**From:** [Symons, Brian D](#)  
**To:** [Sager, John E - DNR](#)  
**Cc:** [Gregory Prom \(MP\)](#); [Jamie Mehle \(SWLP\)](#); [Hughes, Erin](#); [Laszewski, Steve](#); [Saari, Christopher A - DNR](#)  
**Subject:** RE: [EXTERNAL MAIL] SWL&P 100% Design  
**Date:** Wednesday, December 28, 2022 5:16:49 PM  
**Attachments:** [Attachments.html](#)

**UPLAND AREA REMEDIAL ACTION  
 DESIGN DRAWINGS  
 FOR THE  
 FORMER MGP SITE**

**SUPERIOR WATER, LIGHT & POWER**  
 WISCONSIN  
 DOUGLAS COUNTY

**CROSS-SECTIONS  
 FORMER MGP  
 GAS HOLDER**

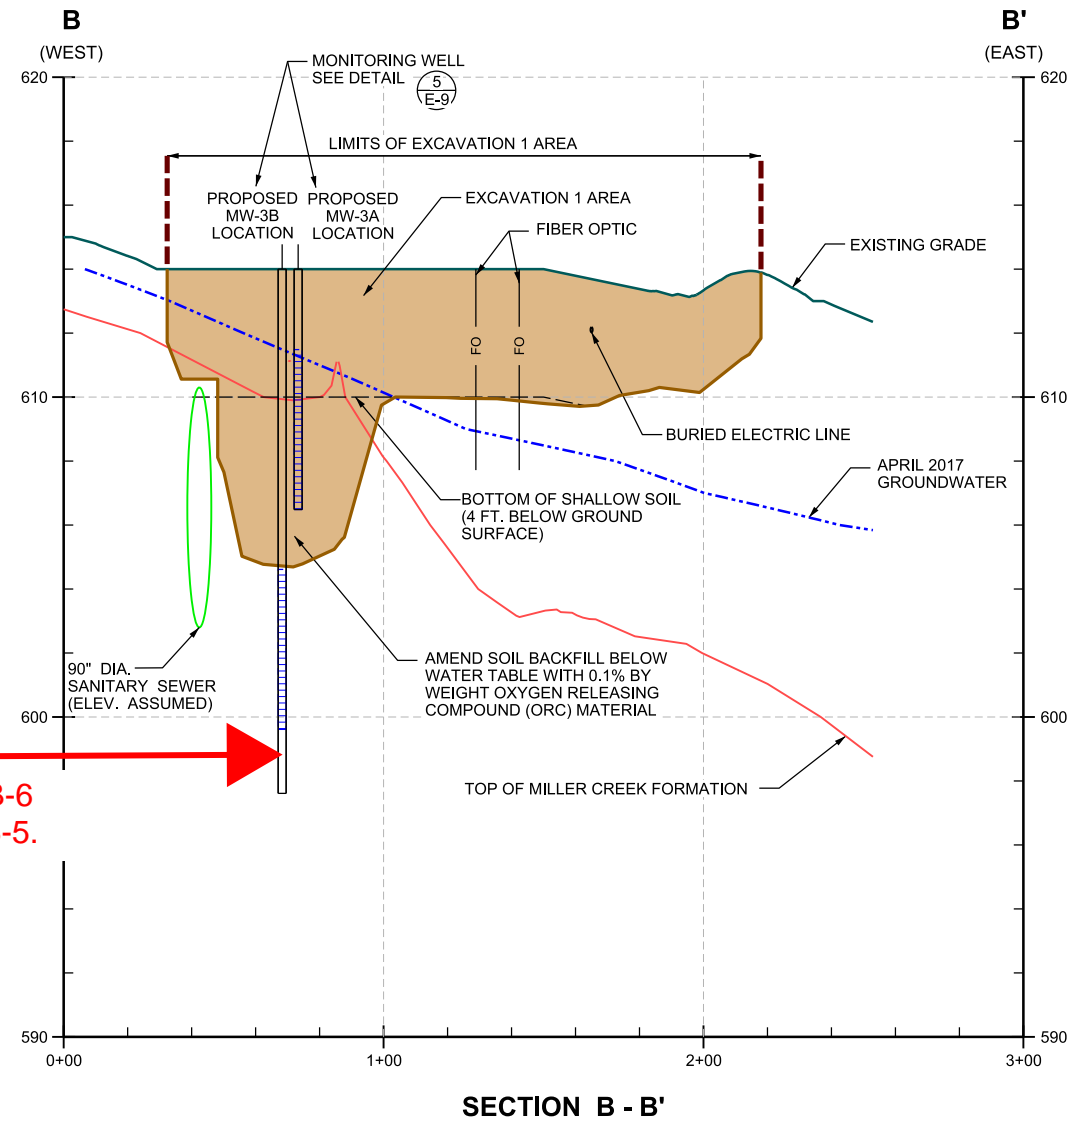
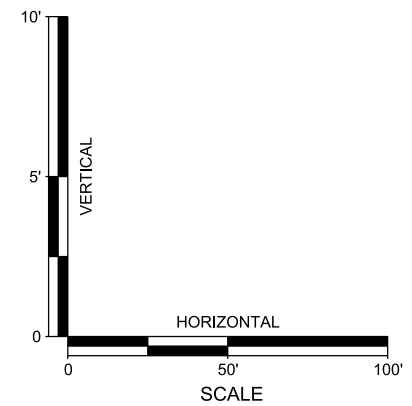
- the screened interval for MW-3B and MW-4B to be installed at approximately 596 to 601ft MSL adjusted to intersect sand layers, if present, and
- the location of MW-29 to be located further west near SLIF-33.

copy changes for MW-4B from B-6 to MW-3B on both sections on B-5.

- the cross-sections for MW-3B or MW-4B screened between 596 and 601 ft MSL (i.e., Drawings B-5 and B-6 in the RAD, ECSWMP, and OM&M Plan) and
- the location for B-29 near SLIF-33 (i.e., Drawing A-8 in the RAD, ECSWMP, and OM&M Plan; FSP Figure 4-1; and AMP Figure 2-1).

**CROSS-SECTIONS  
 FORMER  
 HORTONSHERE**

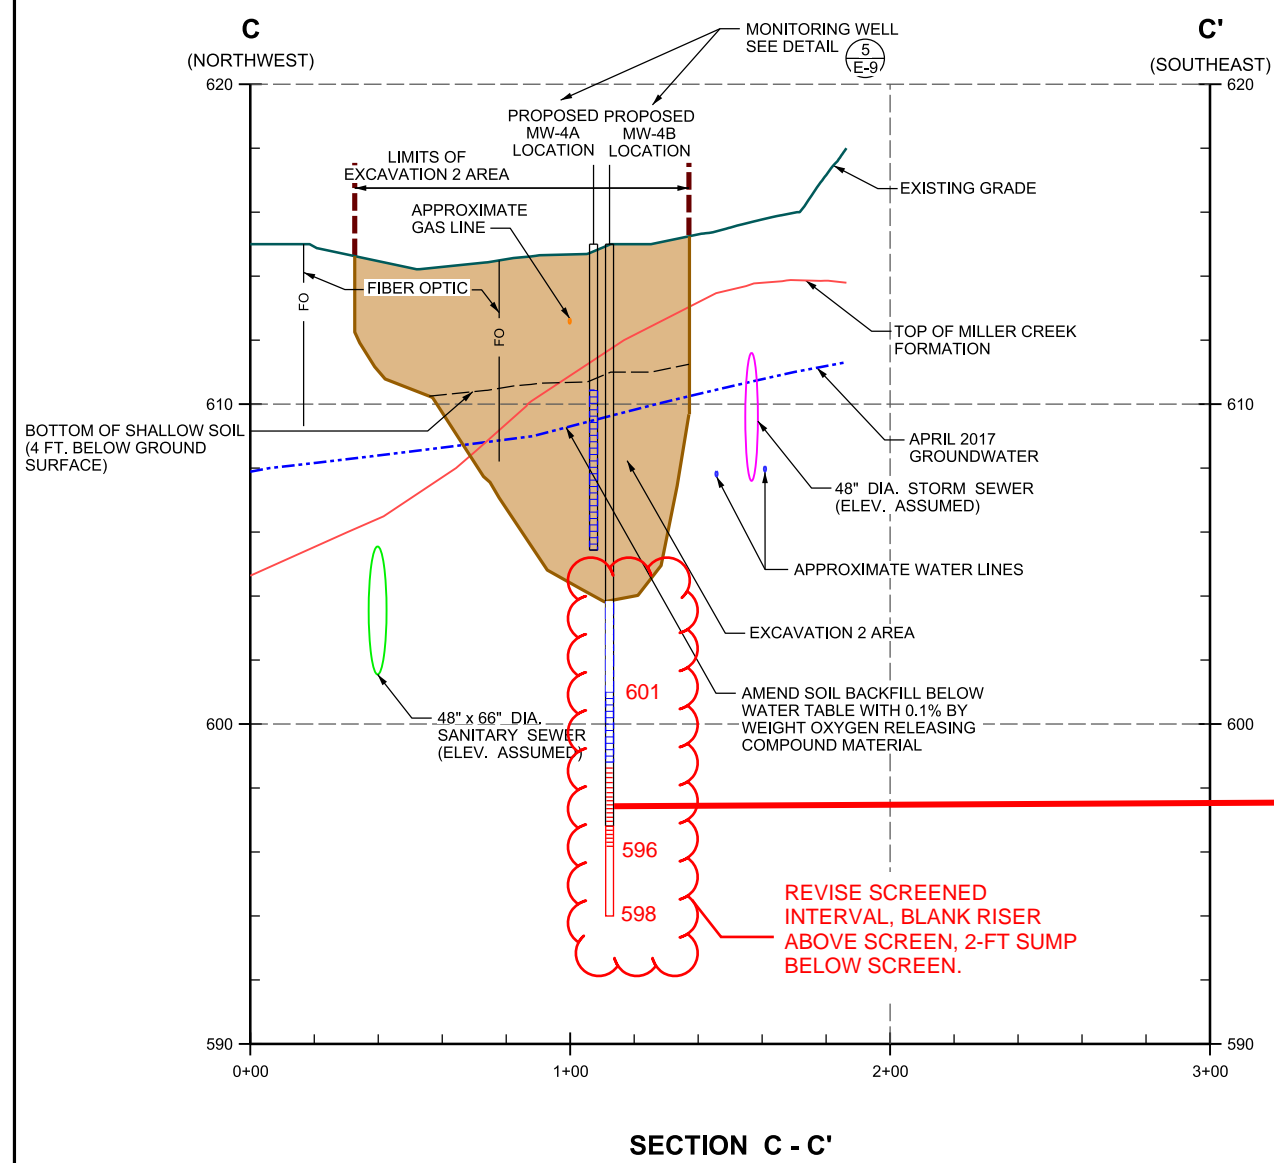
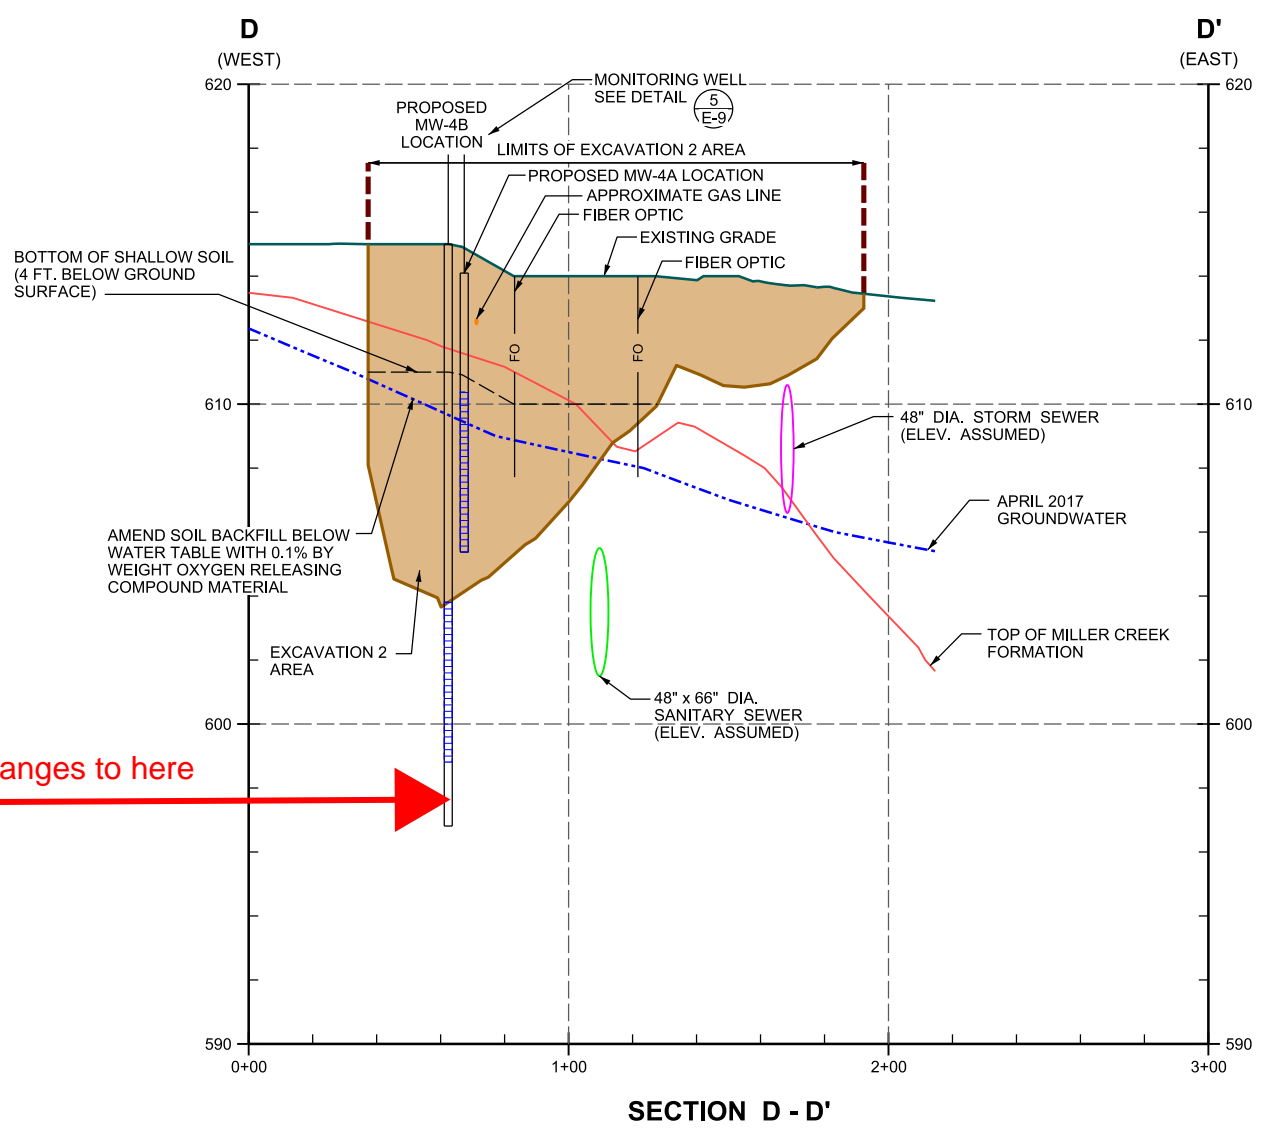
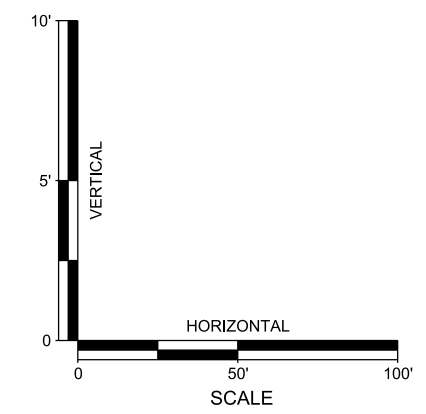
copy changes to here →

**LONG - TERM  
 GROUNDWATER  
 MONITORING  
 NETWORK**

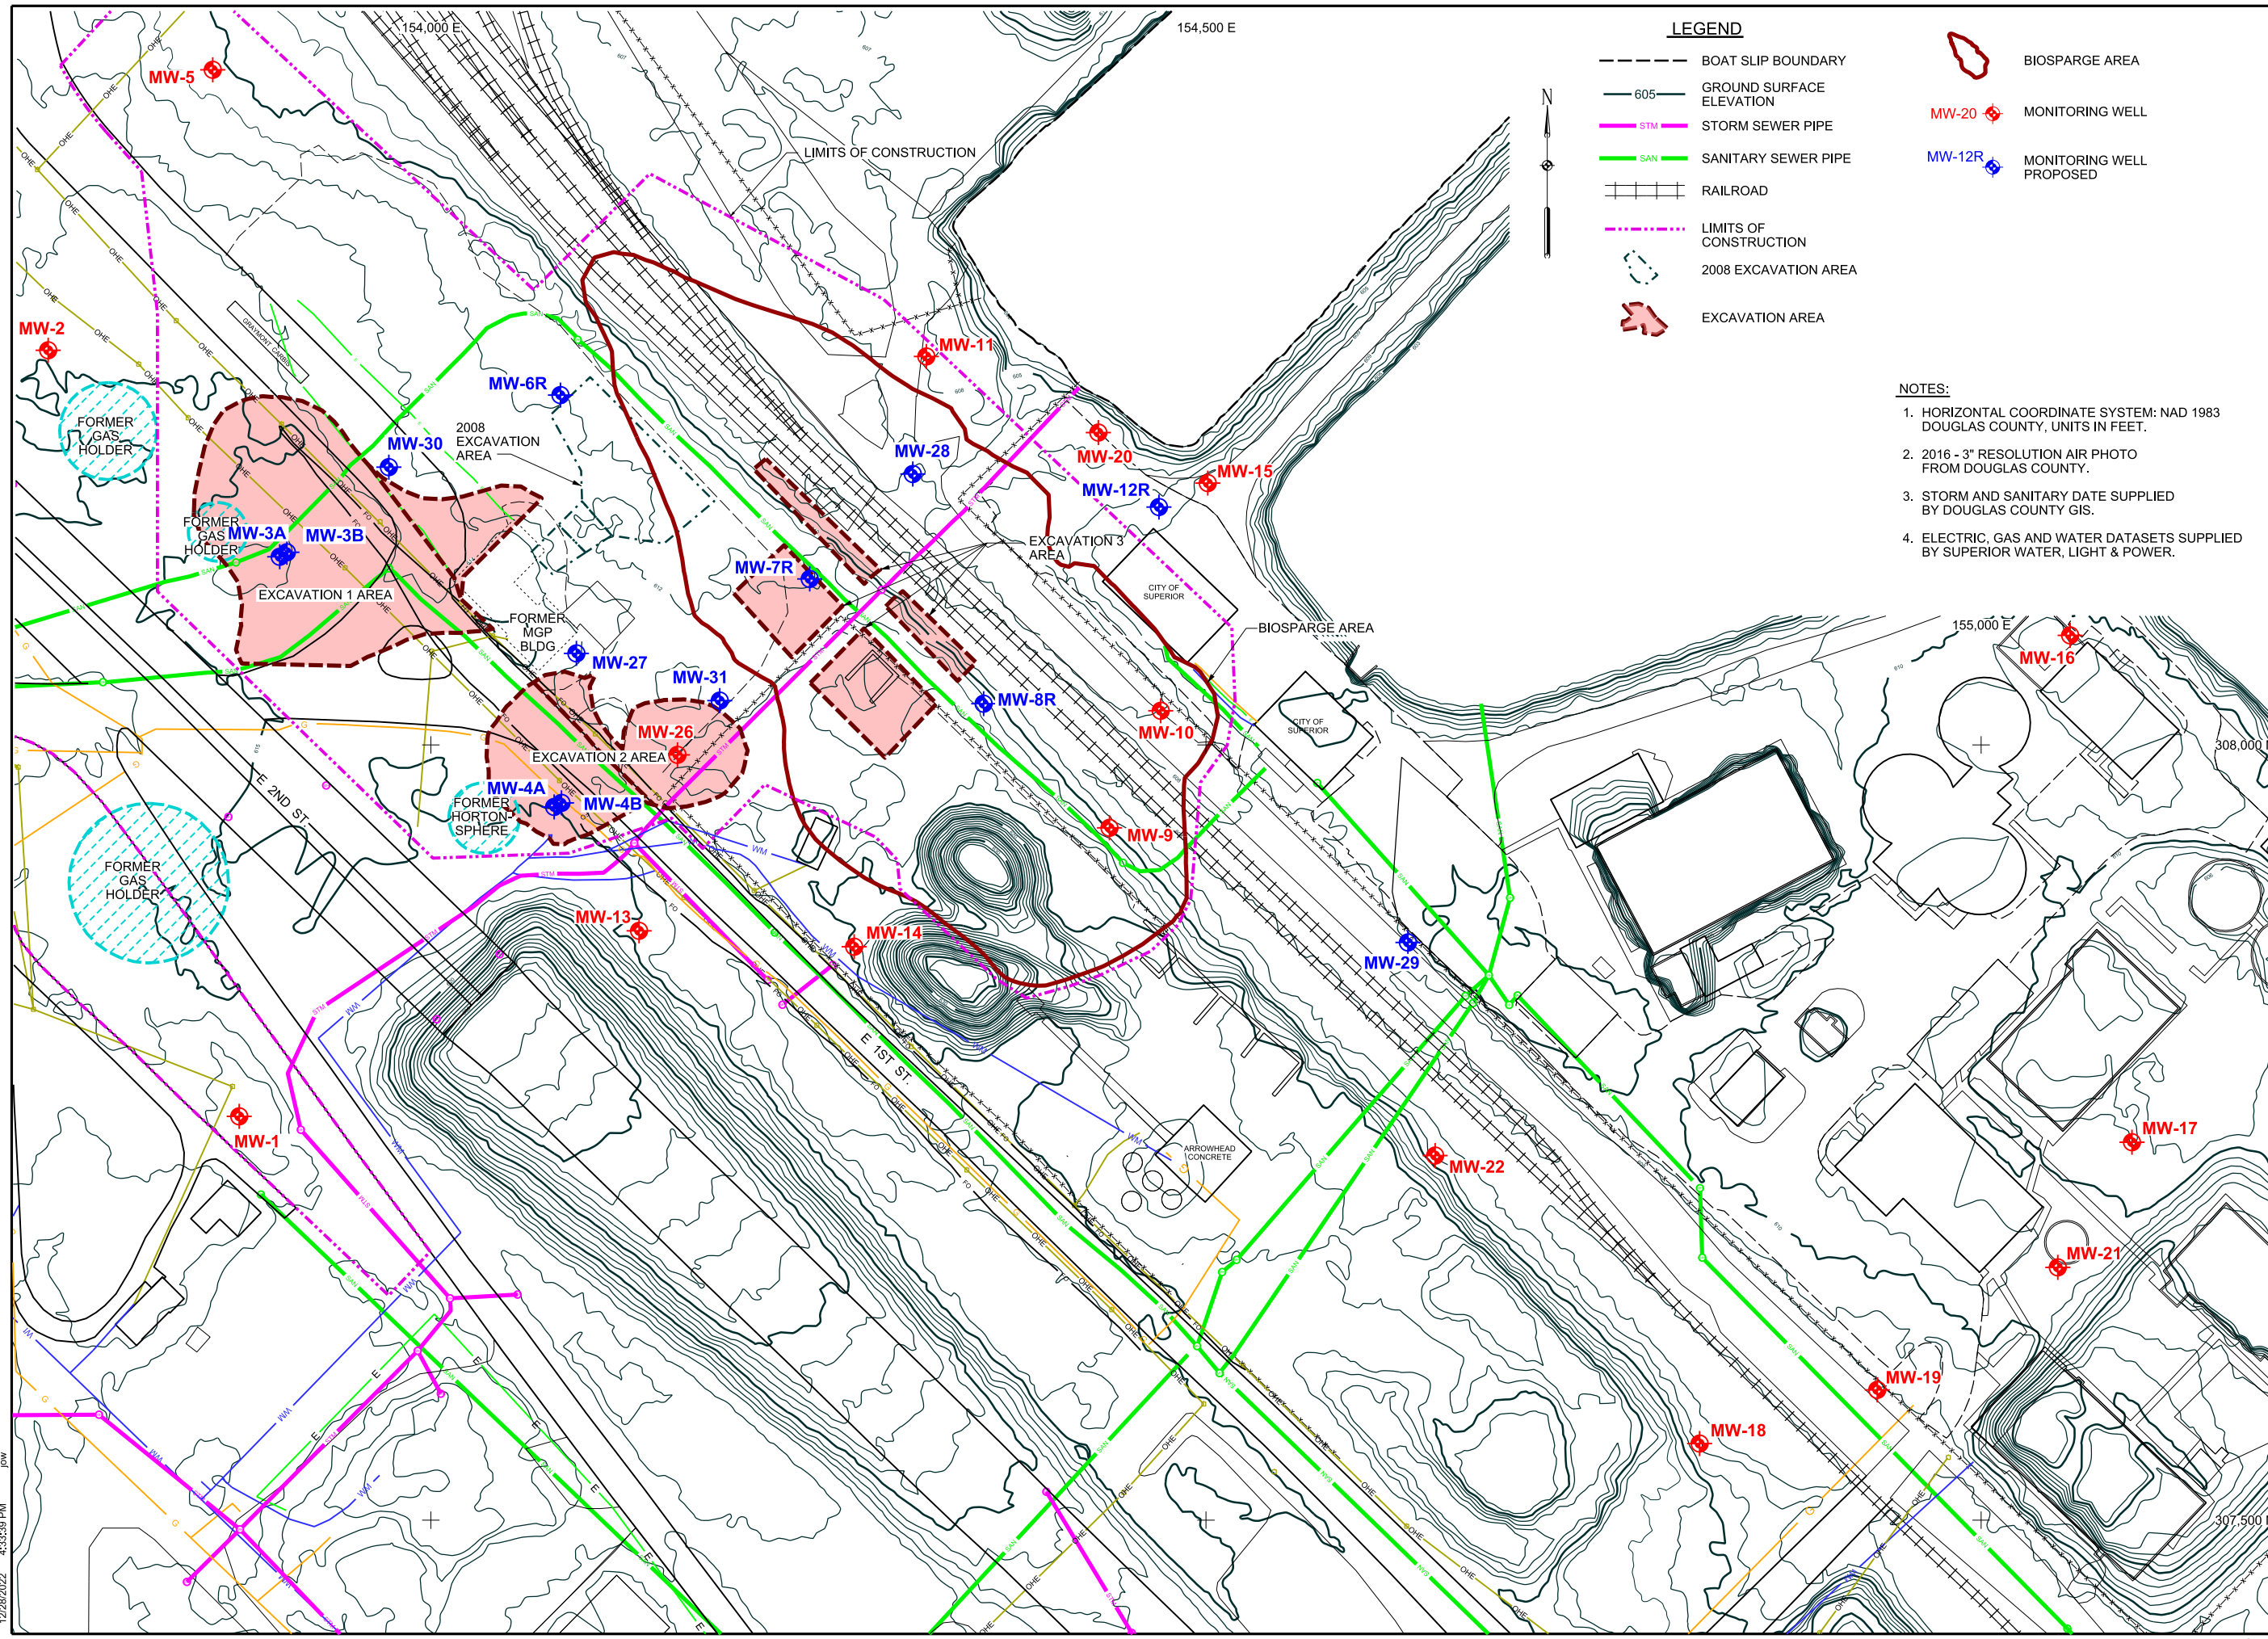
**Also, Foth depicts the location of an additional monitoring well MW-29, further east than the DNR would prefer. The DNR wants a well installed near the location of SLIF-33 to be nearer the active remedial action area to be able to assess groundwater quality near the active remedial action system. Install the well screen to intersect the depths of elevated LIF values.**

Figure 4-1 in Foth's Field sampling plan depicts the well in the same location as in the 90% design. Rather than delaying approval of the entire 100% design over this issue I would like written confirmation from SWL&P and Foth including a new Figure 4-1 depicting the locations

of the proposed monitoring well MW-29 in the location requested by DNR. If SWL&P and Foth would like to retain the location depicted then the DNR requests an additional monitoring well near the location of SLIF-33. If this issue is not addressed it may delay DNR issuing approval of the 100% design report.
